Ground Floor Flat
5 Hillfield Road
London NW6 1QD

Re: Planning Reference 2021/2596/P

**Description: Site R/0 1 Hillfield Road NW6 – OBJECTION TO APP 2021/2596/P
OBJECTION BY 5 HILLFIELD ROAD – OVERSHADOWING ADDENDUM**

**Site Address: Land between Gondar House and South Mansions, Gondar
Gardens and to the rear of Hillfield Road, West Hampstead, London NW6 1QD.**

June 21st
17.00

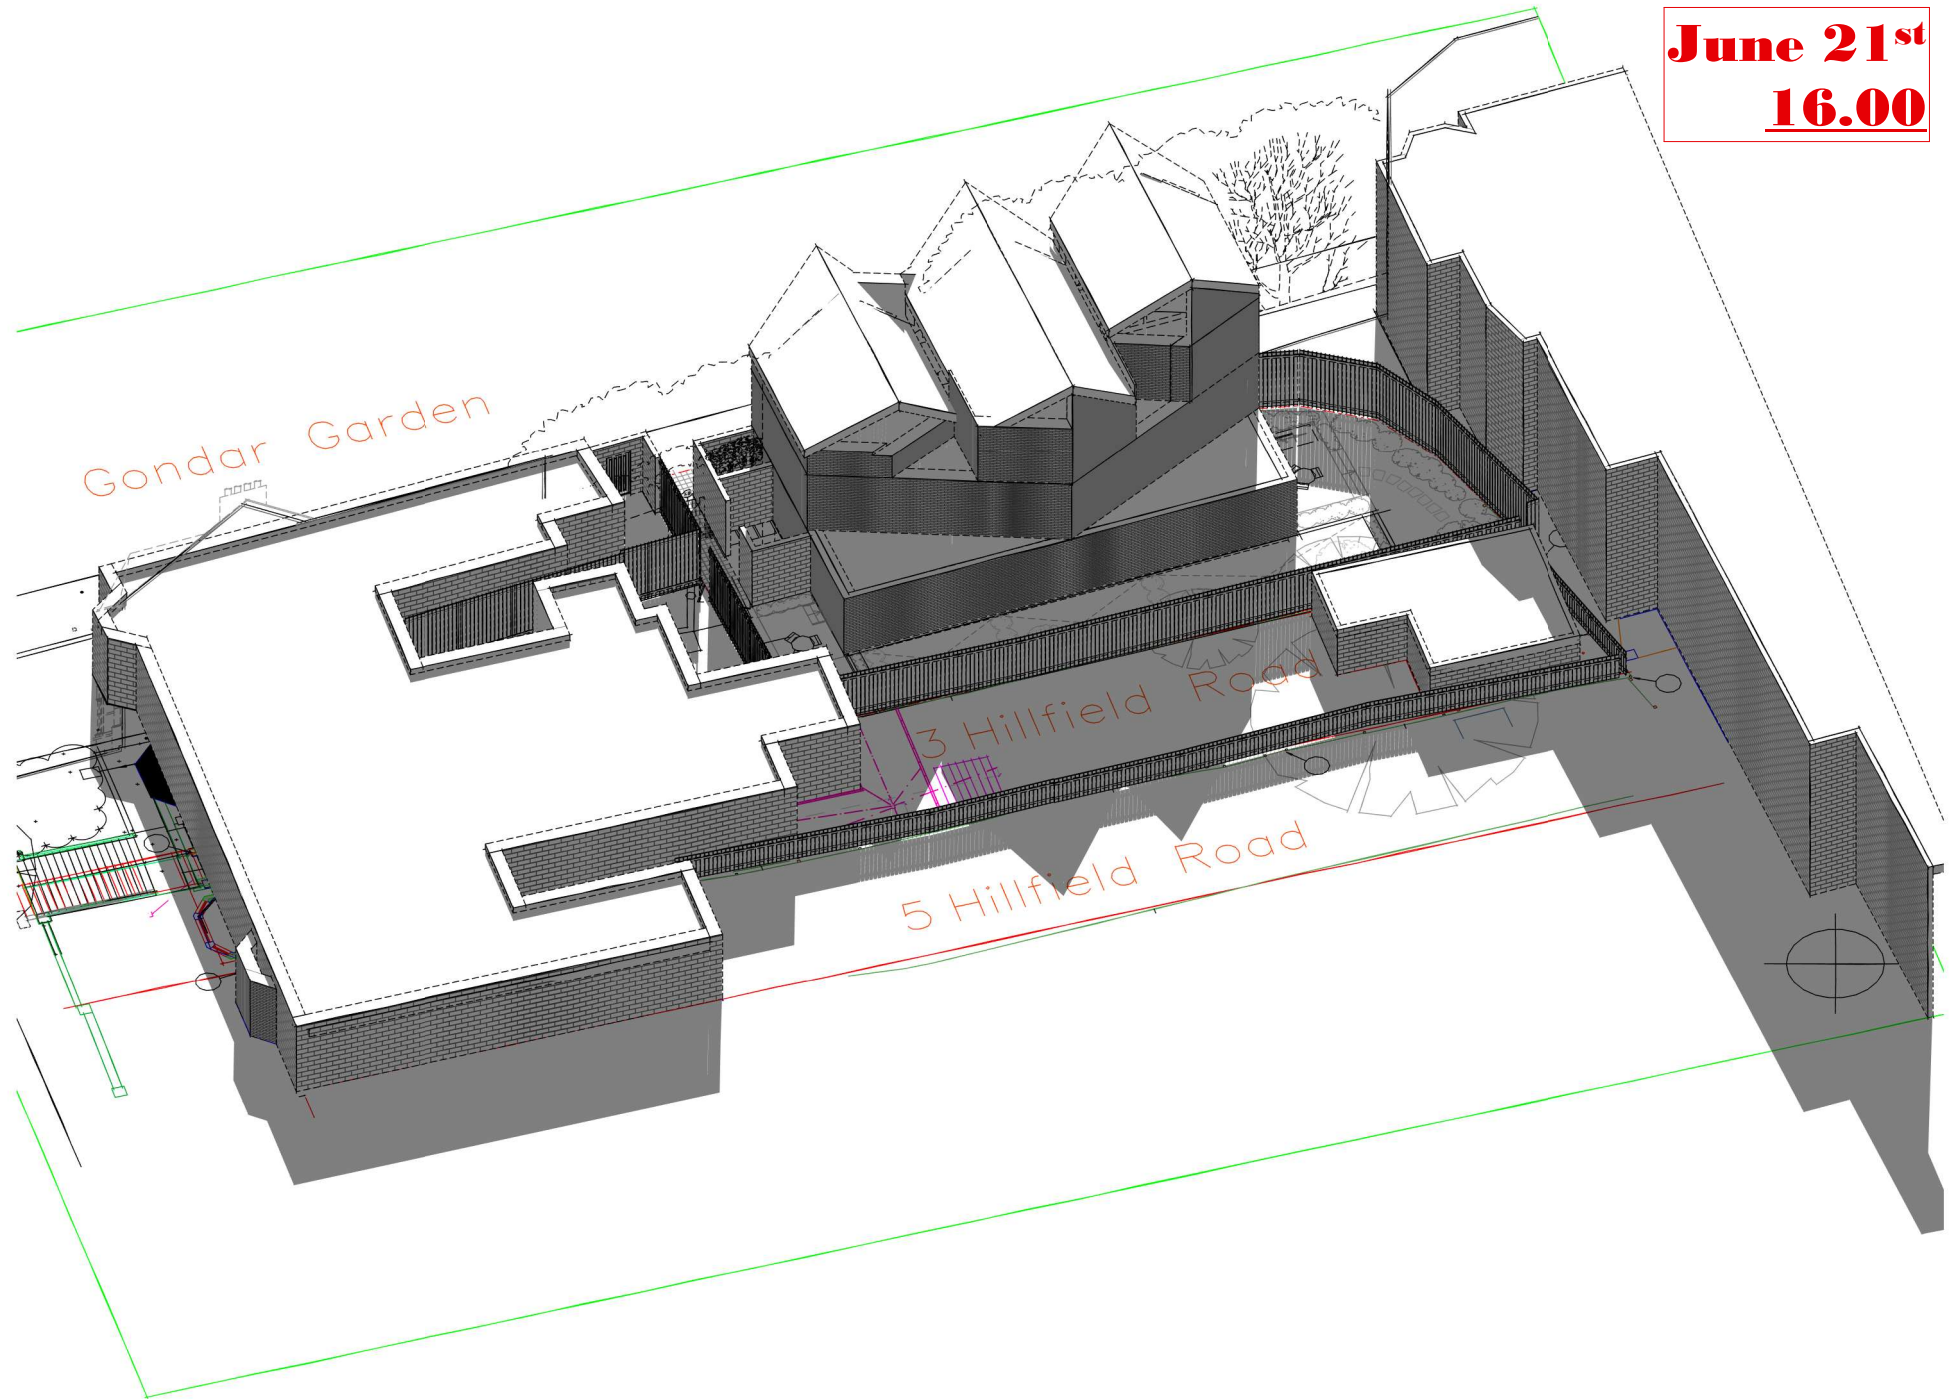
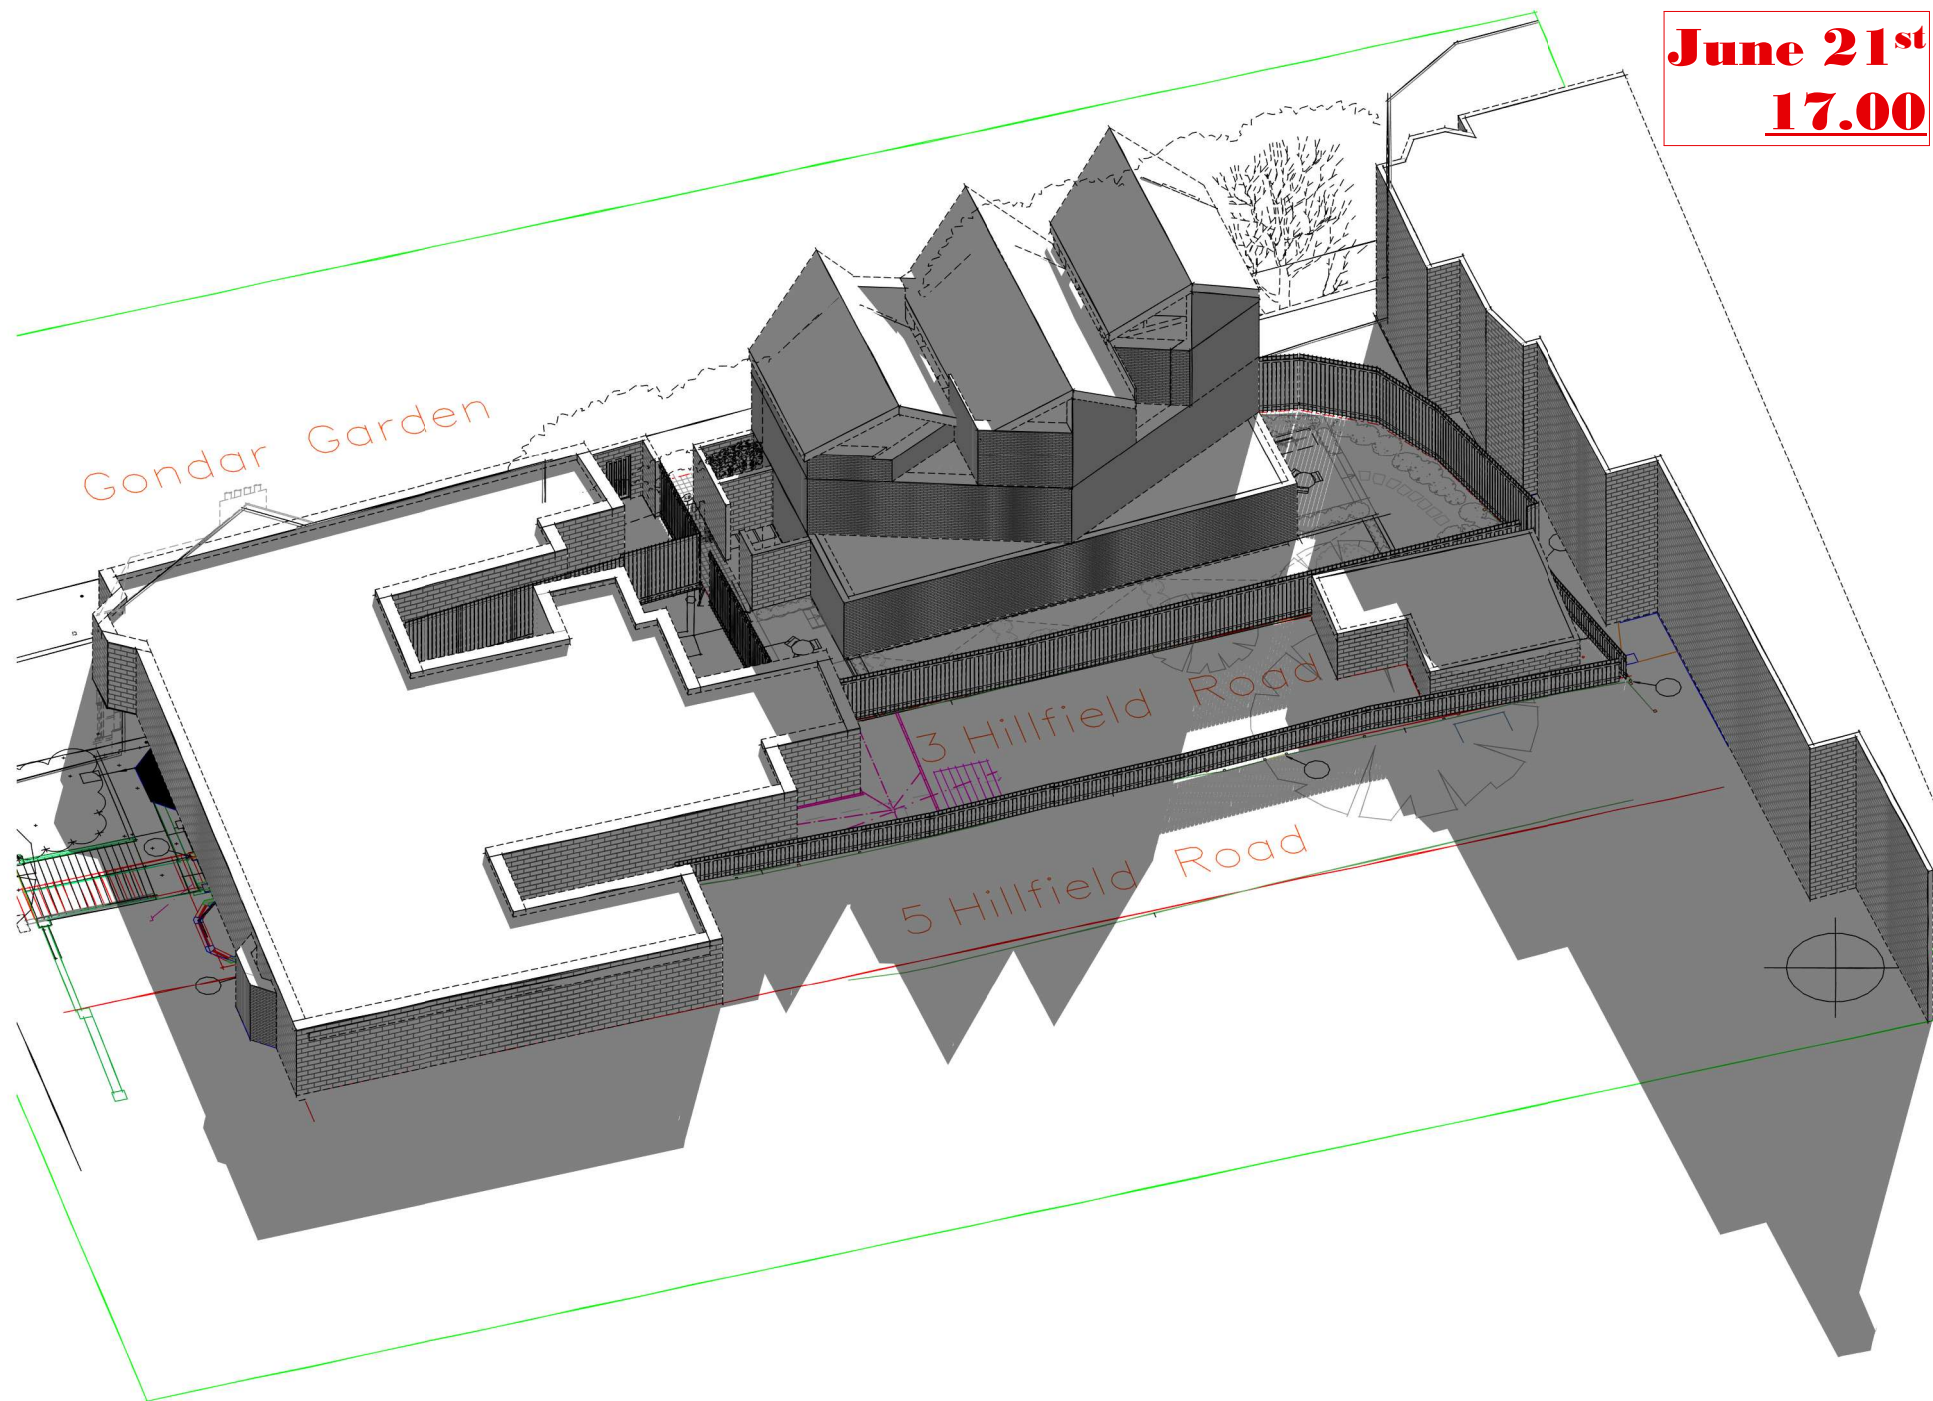
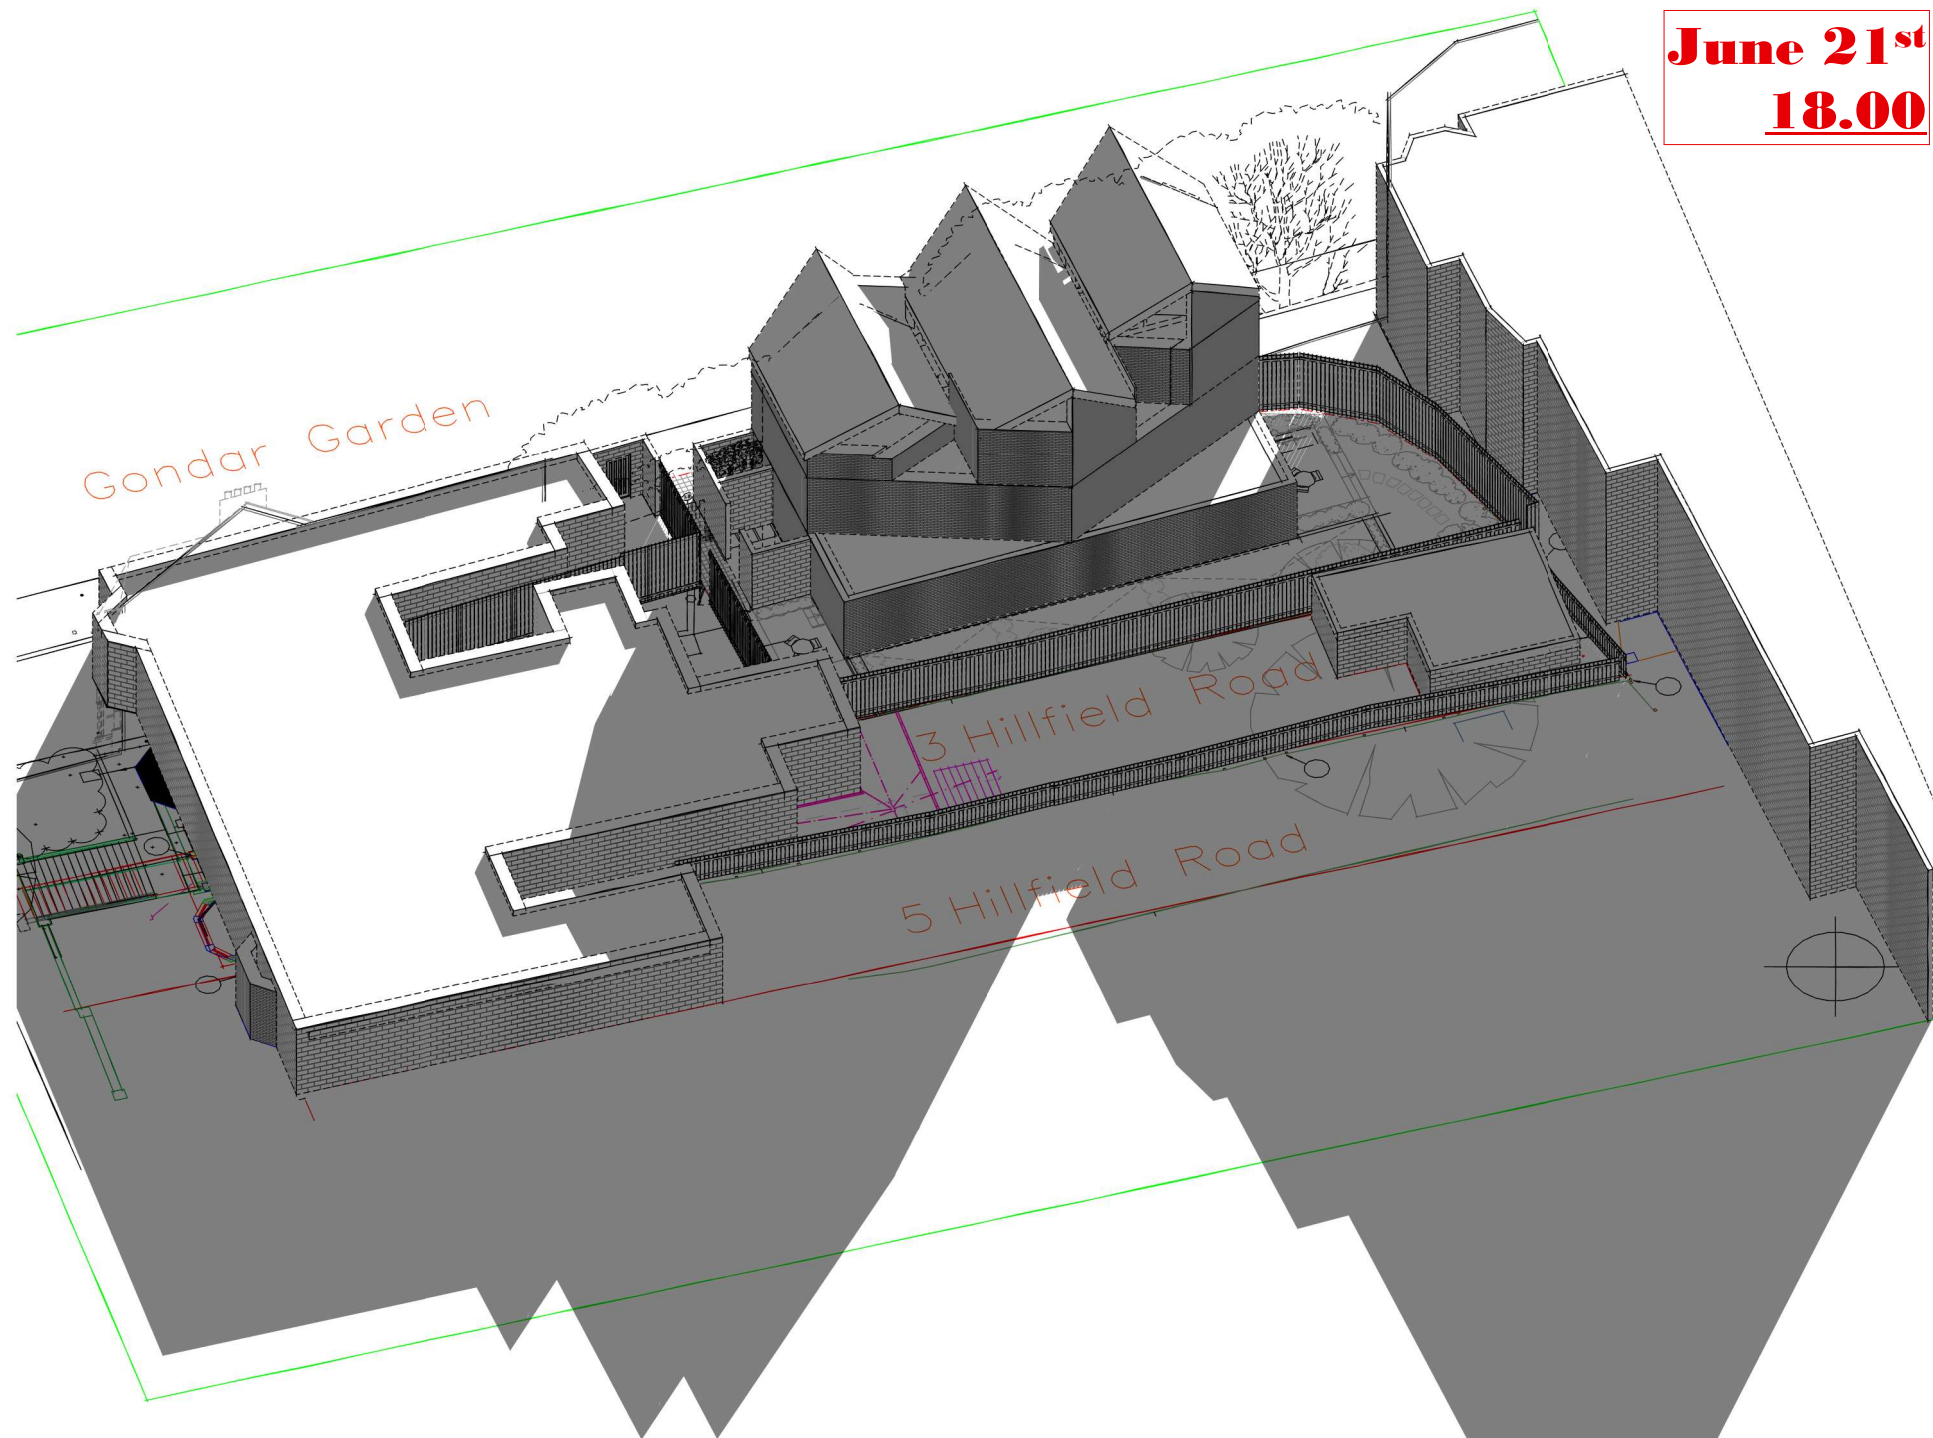
Our own modelling has Gondar House only as ground floor as such the modelling does not show full height of the building and hence not the correct overshadowing on 1 Hillfield Road patio area which will be much worse than the current modelling. The modelling was done to show the extent of overshadowing on 3,5 & 7 Hillfield Road gardens. Also, our model below shows the overshadowing at 21 March. The model shows that the sun is blocked from 14:00 o'clock on 3 Hillfield Road and from 15:00 it is blocking 5 Hillfield Road, the overshadowing continues till sunset at 18:15. We went further to do analysis in June and the overshadowing continues till sunset at 21:00.
